MEMORANDUM

SUBJECT: Bogus Basin Recreational Association Wastewater Reuse Permit Application Review --
LA-000080-03 (Municipal Wastewater Facility)

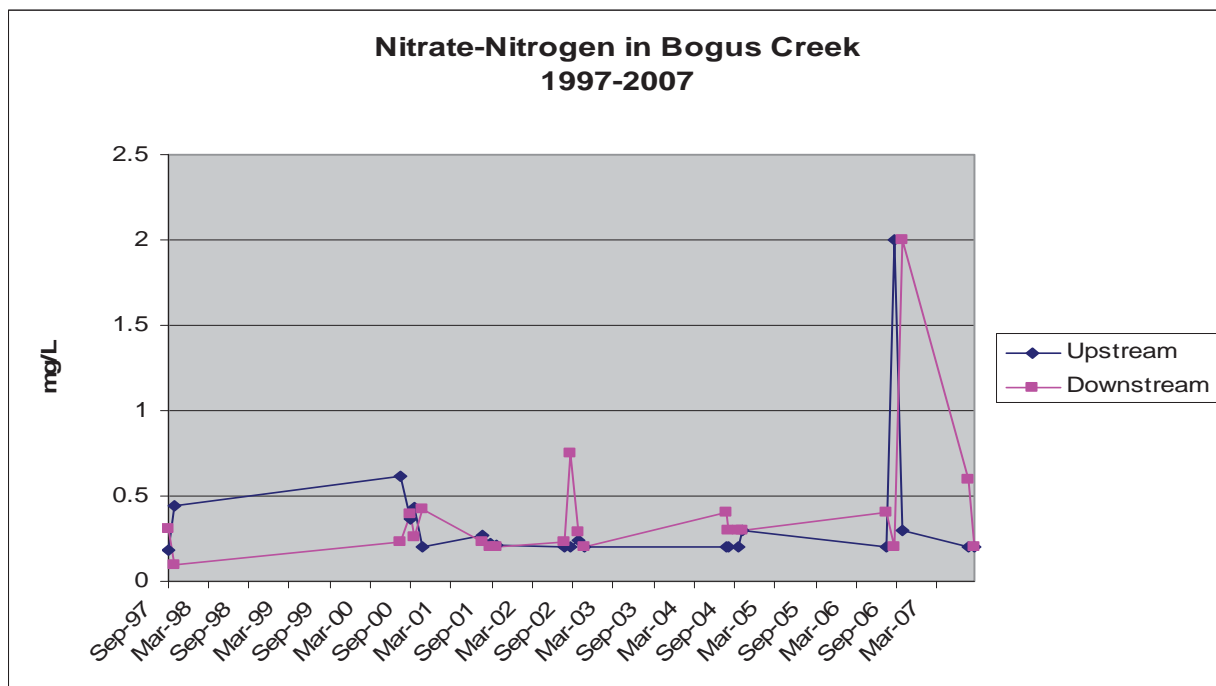
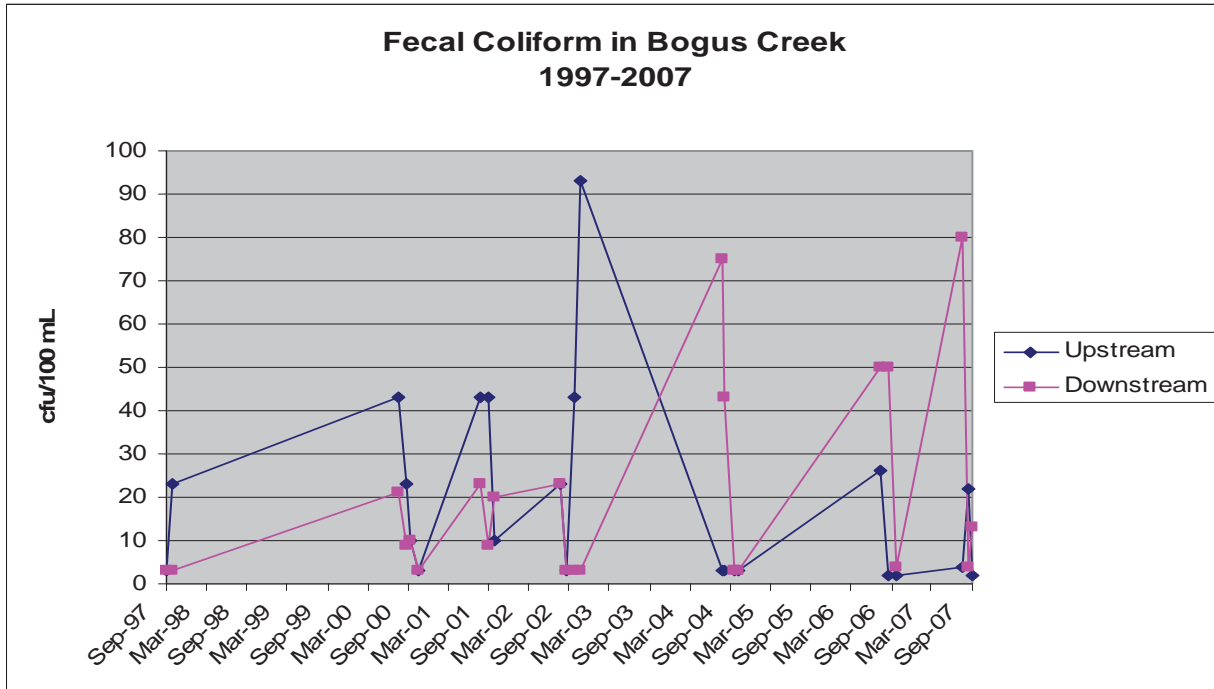
Bogus Creek flows near both the land application site adjacent to Pioneer Lagoon No. 3 and the Bogus Creek Site. However, the Bogus Creek Site is located in much closer proximity to the creek, with the land treatment field being 100 feet away and Bogus Creek Lagoon No. 3 being only 30 feet away. While the application field meets the minimum recommended buffer zone distance for surface water, it was determined during the previous permit renewal process that, given the proximity and the type of wastewater being applied, the creek should be monitored both upstream and downstream for nitrate-nitrogen and fecal coliform. Refer to the plots below for the results of the stream monitoring from 1997-2007.

As evidenced by the graphs above, it appears that the land treatment site has had little to no influence upon the creek waters. Any spikes in either nitrate or coliform downstream are usually preceded by corresponding spikes upstream and at times the water downstream of the site actually appears to be of better quality than that upstream. However, given the proximity of the site to the creek staff feels it is still prudent that monitoring continue through the next permit cycle with the addition of total phosphorus as one of the parameters. See Section 4.5.2.4 for further discussion on phosphorus loadings to the sites and Section 4.7 for further buffer zone discussion. It should also be noted that in addition to the water supplied by the aforementioned production well, the creek also supplies drinking water for various sites at the BBRA. This water is pulled from the creek and filtered near the well location, east of the J.R. Simplot Lodge and well upstream of the land application and lagoon areas.

It is recommended that total phosphorus be added to the surface water monitoring requirements for Bogus Creek as discussed in Section 4.3. See Section G of the draft permit.

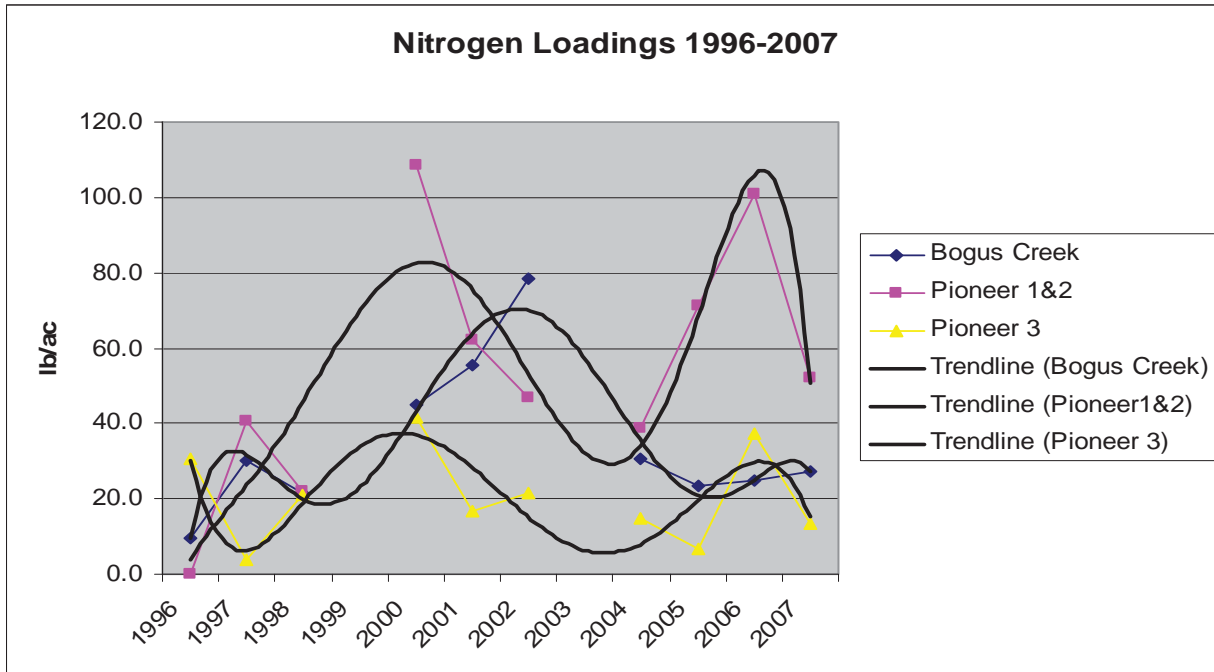
The nitrogen concentration of the systems' wastewater appears to fluctuate a fair amount from year to year, possibly due in part to the facility's sampling procedures. These variations in concentration have consequently lead to corresponding oscillations in nitrogen loading rates, particularly at the Pioneer Lagoon No. 1 and No. 2 Site. Refer to the graph below for the nitrogen loadings to the land application fields during the previous permit cycle (1996-present).

Despite these rather wide variations, each of the sites' average loading rates over the past decade has been well below the proposed loading rate. There have only been a few instances where the 70 lb/ac mark has been exceeded, twice on the Pioneer 1&2 Site and once on the Bogus Creek Site. As was previously mentioned, a certain amount of these concentration and loading rate fluctuations could be due to the way the facility is sampling, as the wastewater influent and effluent quality should in theory remain the generally the same each year provided all lagoon systems are functioning properly. In is unclear as to exactly where and how the facility has been drawing their wastewater samples in the past. Many of them may have come directly off the surface of the lagoons themselves, which are often coated with algae during the summer months, affecting the quality of the sample; this is particularly true of Pioneer Lagoon No. 2 which is currently un-aerated and therefore less well mixed. In order to address this ambiguity and in the hopes of retrieving a more standard and representative picture of the facility's wastewater, staff recommends that the facility draft a Quality Assurance Project Plan which covers field activities including laboratory analytical methods and other activities; data storage, retrieval and assessment; and monitoring program evaluation and improvement. For the full text of this condition see CA-080-02 in Section E of the permit.

In the event that the nitrogen loading rate fluctuations discussed above are not resolved through the increased scrutiny of sampling methodologies, and specifically, if annual loading rates continue to drift above the permit limit of 70 lbs/ac, the provisions of Compliance Activity CA-080-04 require that BBRA investigate the treatment process for potential improvements that would reduce the nitrogen loading rates. The improvements to be evaluated should include both operational changes, as well as the potential for system modifications, such as adding aeration to Pioneer Lagoon No. 2. This provision will only be triggered if the nitrogen loading rates exceed the loading rate limit contained in the permit. Refer to CA-080-04 in the draft permit for additional details.
